Engineering Change Request		ECR Number	R10603W-2
Initiator:	Scott	Date:	2026/09/28

Item	K3 Code material part numbers	Drawing/ Doc Number	Version of current related document	New Version
1	HVCOCMCR8PFXXXLXXX Series	/	/	/

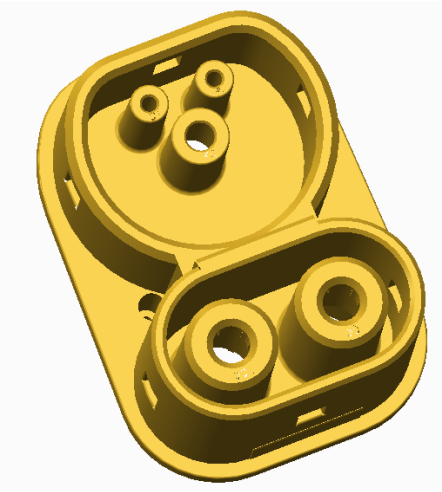
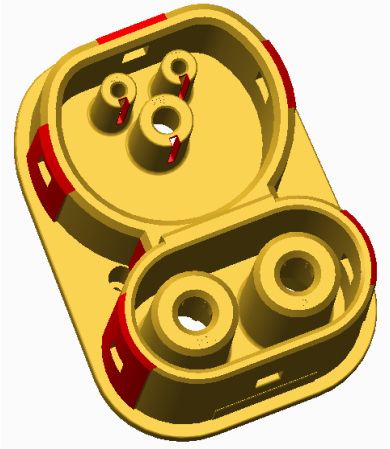
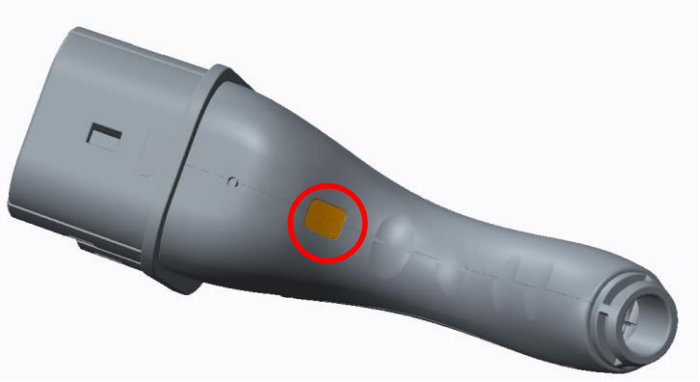
Before change	After change
1. 	1. Upgrade the charging connector interface in accordance with standard IECPAS63472-2023, add drainage for CP/PP/PE 
2. 	2. Change the position of potting hole on the handle

Modify the existing IEC62196-2-2022/IEC62196-3-2022 complied charging connector interface according to standard IECPAS63472-2023, and add drainage for CP/PP/PE. Meanwhile, change the position of the potting hole to facilitate production processes, with no impact on product performance/function.
